# State of Utah

Division of Oil, Gas and Mining

## Inspection Report

Permittee: **CONSOLIDATION COAL CO**  
 Operator: **CONSOLIDATION COAL CO**  
 Site: **EMERY DEEP MINE**  
 Address: **PO BOX 566, SESSER IL 62884**  
 County: **EMERY**  
 Permit Type: **PERMANENT COAL PROGRAM**  
 Permit Status: **ACTIVE**

Below, site #1, Subsoil Pile from Ponds 4 & 5 (11.8% desirable cover in 2003)

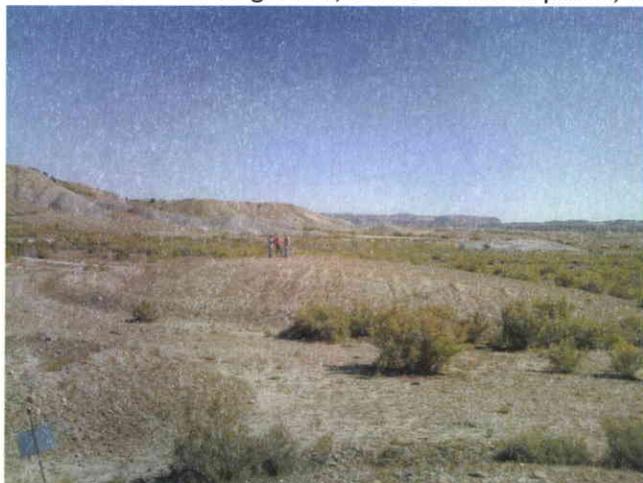
For topsoil and subsoil stockpile Sites # 1, #2, #9, #10, the vegetation on the level surface of these stockpiles appeared quite similar to the gently sloping, undisturbed surroundings. But on all piles, lower vegetation on the slopes was less than that of the desert shrub reference area. The reference area is located on fairly level ground, on top of the ridge. The difference in % desirable cover between these stockpiles and the reference area is likely due to topographic differences. Therefore, no action is recommended on these sites.
